### **TECHNICAL BULLETIN**

FAM-A-0002-A

# **Change of Authentication Labels for Genuine Products and Nameplates**

Date of Issue
May 2020
Relevant Models
MELSEC iQ-F series, MELSEC-F series

#### Label of authenticity

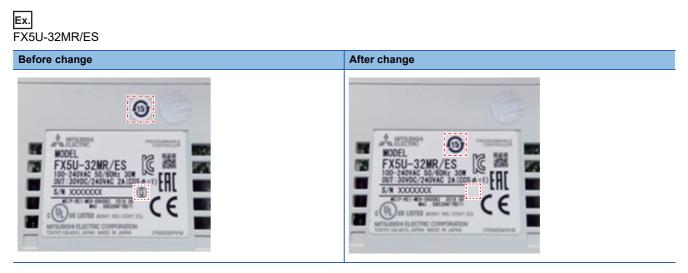
The following changes will be made to the label of authenticity.

Item	Before change	After change
Design	Silver (black and white)	Blue and yellow (colored)
	EX EX EX EX EX EX EX EX EX EX EX EX EX EX EX EX EX EX	SEC MELSEC MELSE
Details	Turning the label 90 degrees inverts white and black.	Turning the label 90 degrees inverts white and black.
	FX FX FX FX FX FX	SEC MEISEC MEISEC MEISECY
	-	The background color changes to gray when the label is tilted vertically.
		COMISSION HISTORY
